ITB16-018b

## VOLUNTARY SAFETY RECALL CAMPAIGN OCCUPANT CLASSIFICATION SYSTEM CONTROL UNIT REPLACEMENT

This bulletin has been amended to add an alternative method for performing zero point reset using BOSCH MTS 6513.  
No other changes were made. Please discard previous versions of this bulletin.

CAMPAIGN ID #: R1606  
NHTSA #: 16V-244  
APPLIED VEHICLE: 2013 JX (L50)  
2014-2016 QX60 (L50)  
2014-2016 QX60 Hybrid (L50)  
2014-2016 Q50 (V37)  
2014-2016 Q50 Hybrid (V37)

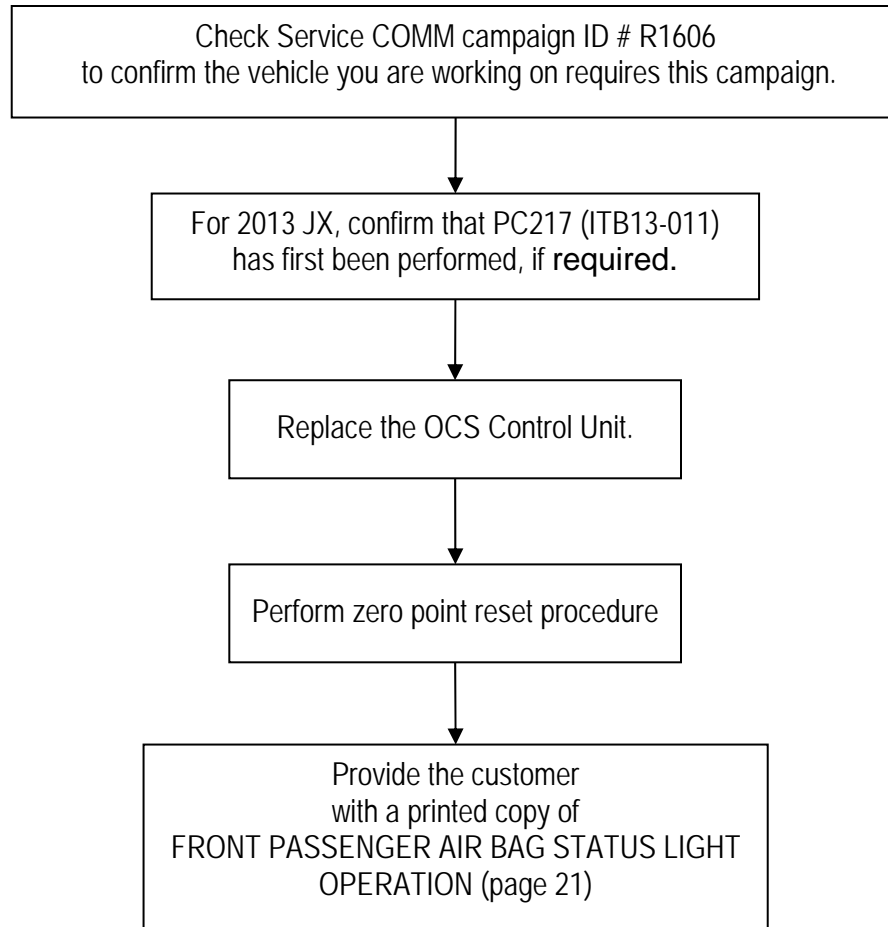
Performing the procedures in this bulletin (campaign R1606) changes the operation of the passenger air bag status light.

- After performing this campaign, the passenger air bag status light will be ON (illuminated) when the front passenger seat is empty.
